Ku-ring-gai Council Submission

Major Project MP08_0244 –Environmental Assessment –
Mixed Use Development - 23-37 Lindfield Avenue and 11 Havilah
Avenue, Lindfield

December 2010

1A

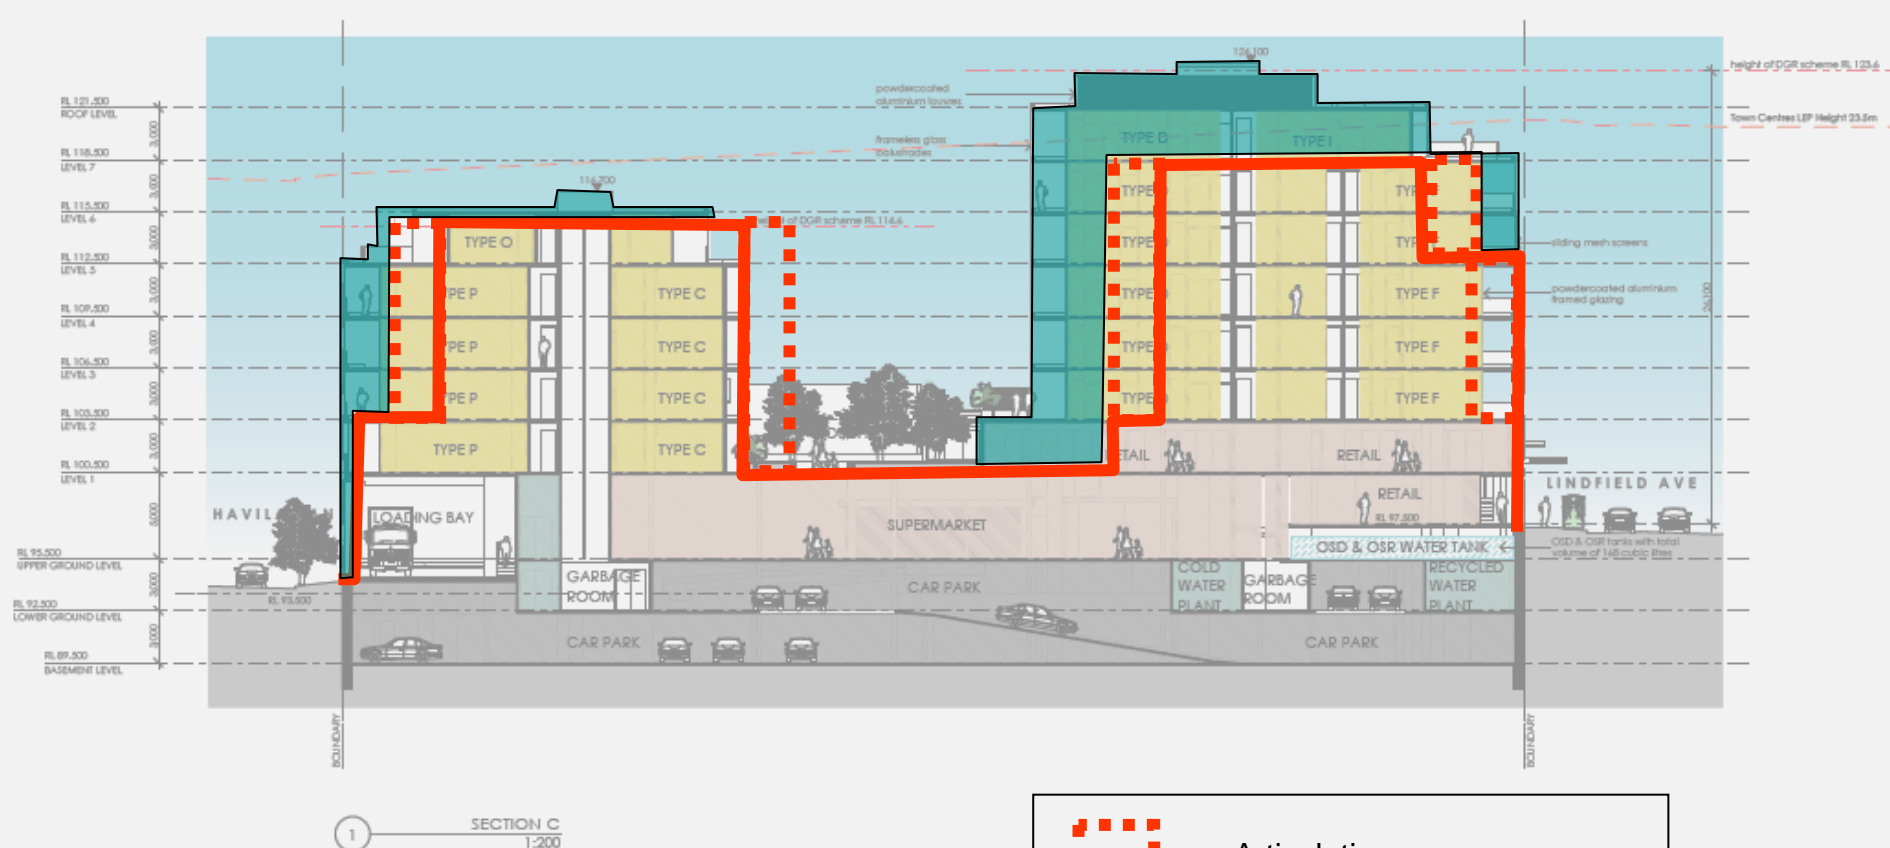
- Excessive building height and bulk
- Non-complying building depth
- No substantial evidence that proposal would meet urban design excellence criteria and therefore warrant additional height and FSR
- Heritage impact as street wall principles and controls not addressed on Lindfield Ave
- SEPP 65 building separation non-compliance across Havilah Lane
- SEPP 65 building separation non-compliance between residential building elements
- Retail floor to ceiling heights inadequate/inaccurate
- No active frontage to Havilah Lane

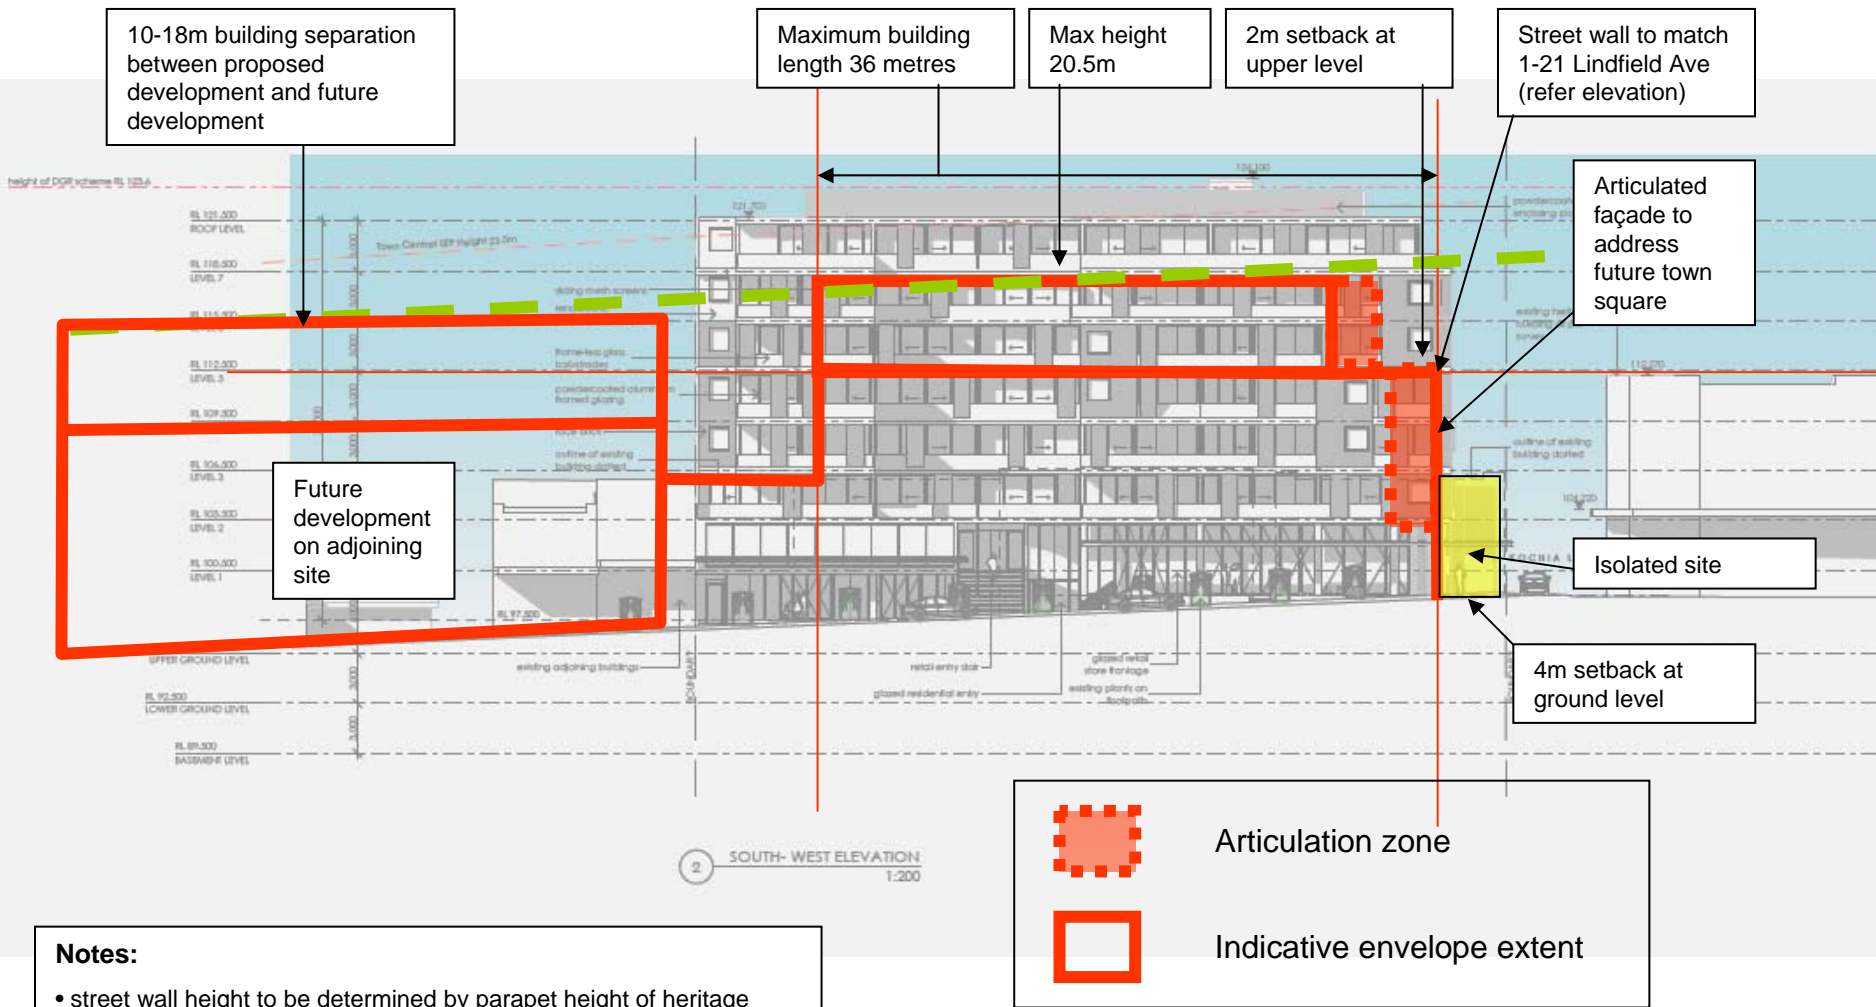
Indicative non-compliance
